**EBASCO SERVICES INCORPORATED****EBASCO**

Subject: Ebasco's Topical Report ETR-1001, Rev. 13

EBASCO SERVICES INCORPORATED	NUCLEAR QUALITY ASSURANCE PROGRAM MANUAL	SECTION QA-I-2
	ORGANIZATION AND RESPONSIBILITIES	REVISION 7
		DATE

FIGURE 1-2.2  
REV. 7

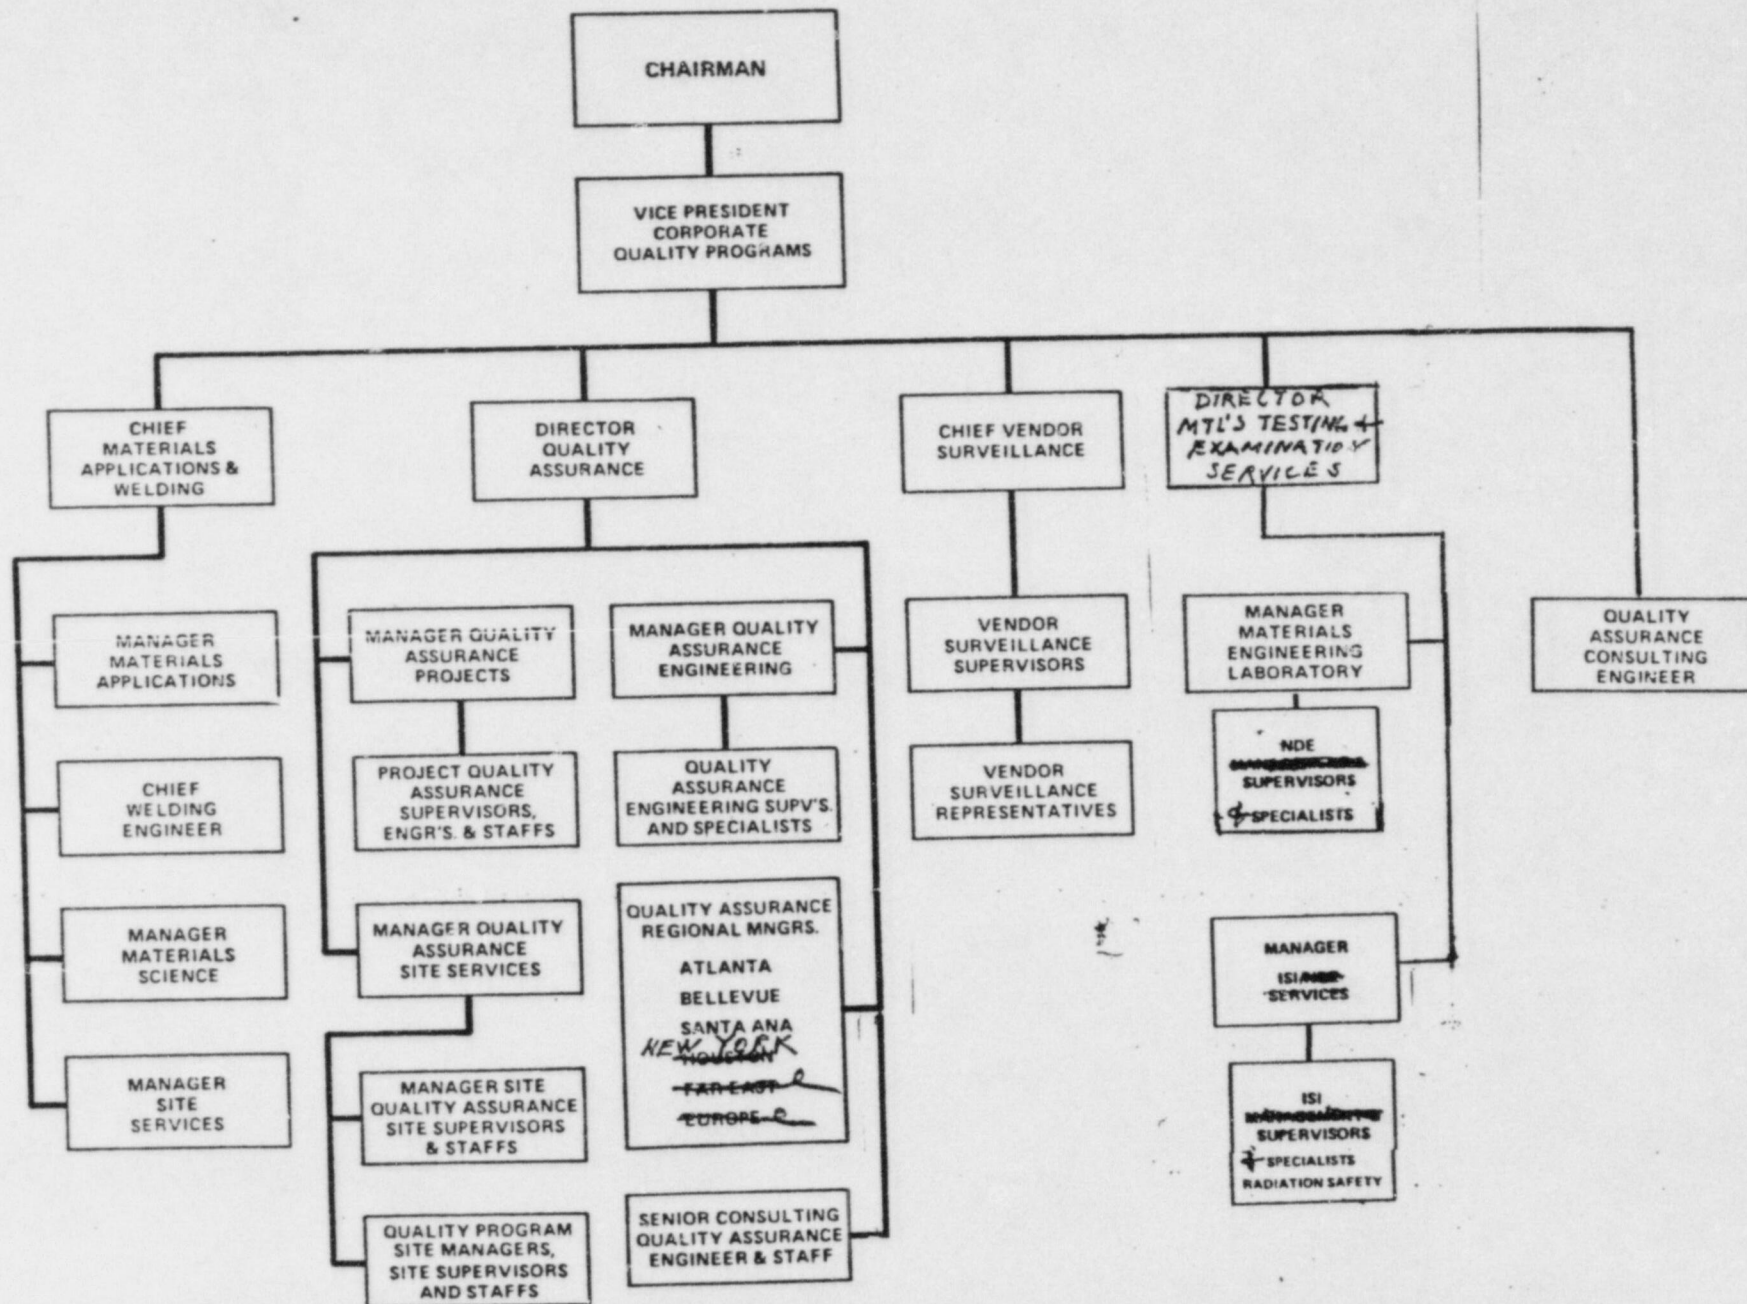
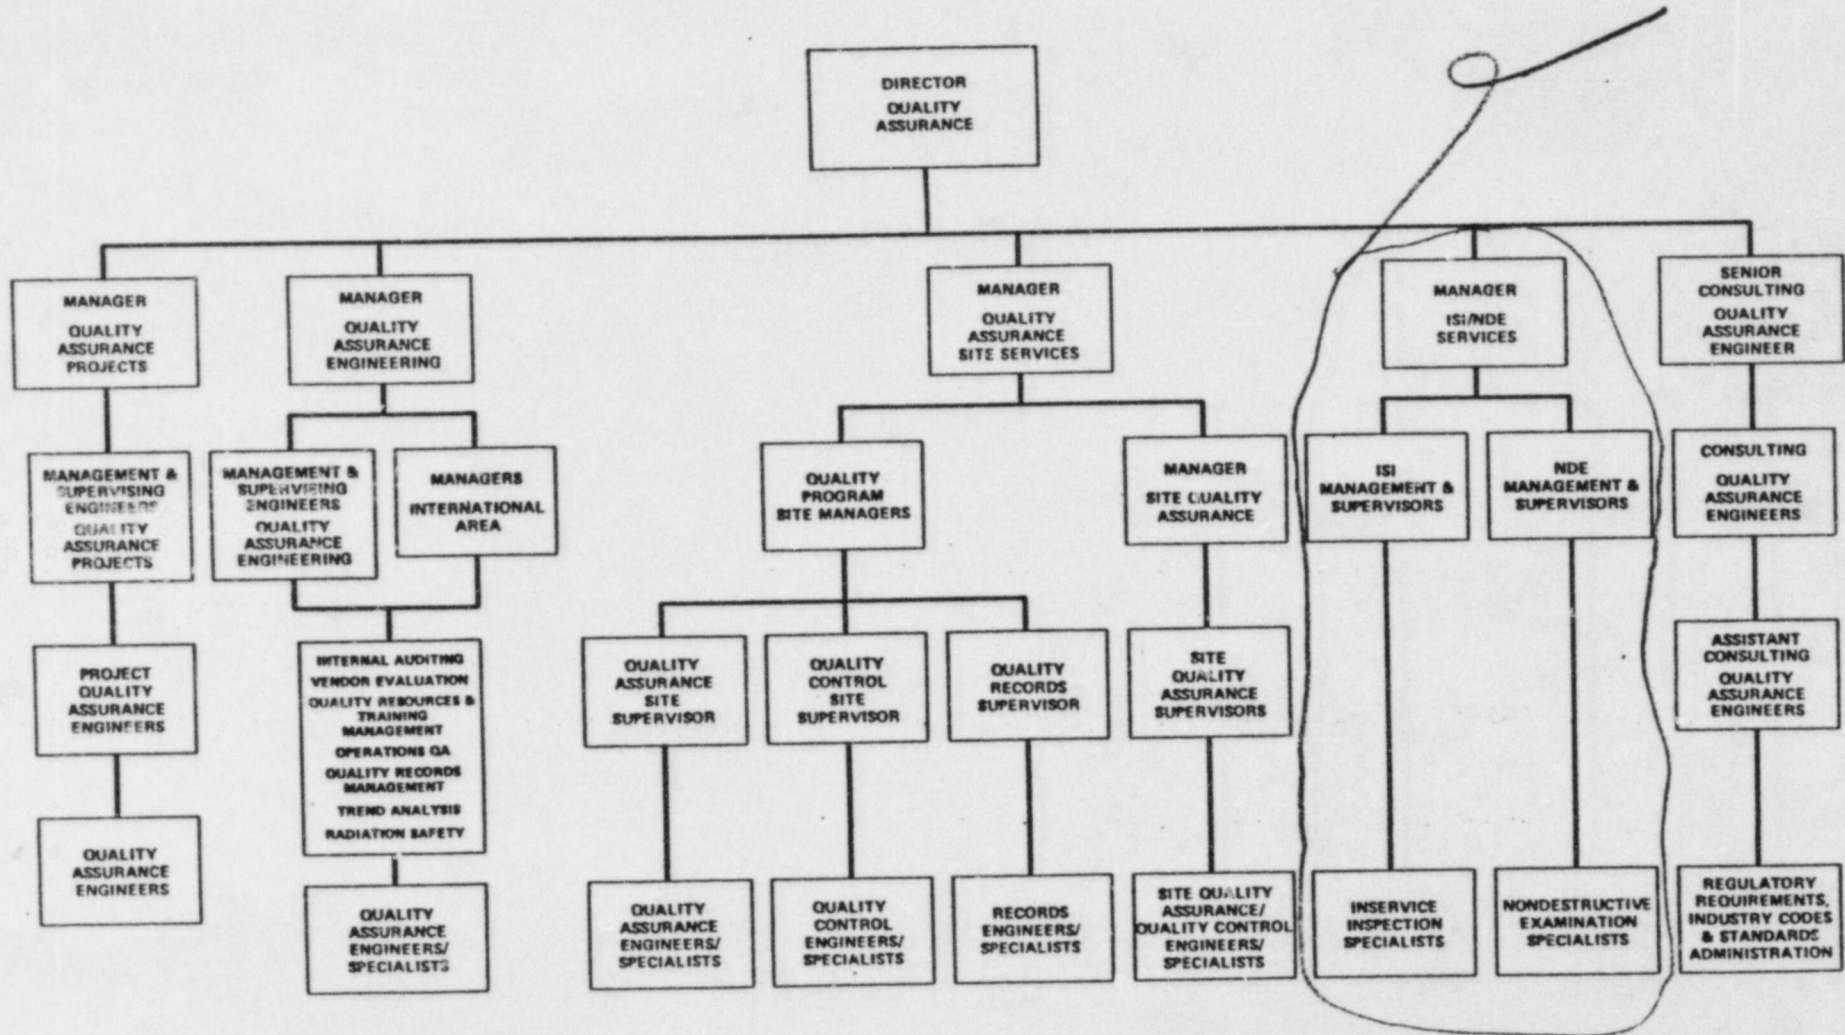
1. d) A Legend will be added to Figures I-2.1 and I-2.2 indicating that the dashed line pertains to "communication" between parties.

1. e) We will revise Figure I-2.2 to delete reference to the "Far East" and Europe" and substitute "New York" for "Houston".
1. f) We will include the text pertaining to Ebasco's Corporate Radiation Safety Officer, as you suggest, under the Part of Section QA-I-2 that pertains to ISI/NDE Services. However, as the result of a recent organizational change this function will be shown only on Figure I-2.2 (see attached proposed changes) because it no longer is part of Ebasco's Quality Assurance Organization.
1. g) We will revise Part 3.1 of Section QA-I-2 to delete ISI/NDE Services because of the reason explained in 1. f) above and add a new subdivision, i.e., QA Regional Managers. At the same time a new Part 3.1.5 in Section QA-I-2 describing the responsibilities of the QA Regional Managers will be added, as follows:

3.1.5 Quality Assurance Regional Managers - A Quality Assurance Regional Manager is assigned in each one of the Regional Offices shown on Figure I-2.2. Each Quality Assurance Regional Manager is responsible for quality assurance implementation and direction of those projects assigned to the noted Regional Office. Reporting Supervisors and/or Quality Assurance Engineers with the same responsibilities and tasks, as applicable, as described in Paragraph 3.1.1.1 of this Section.
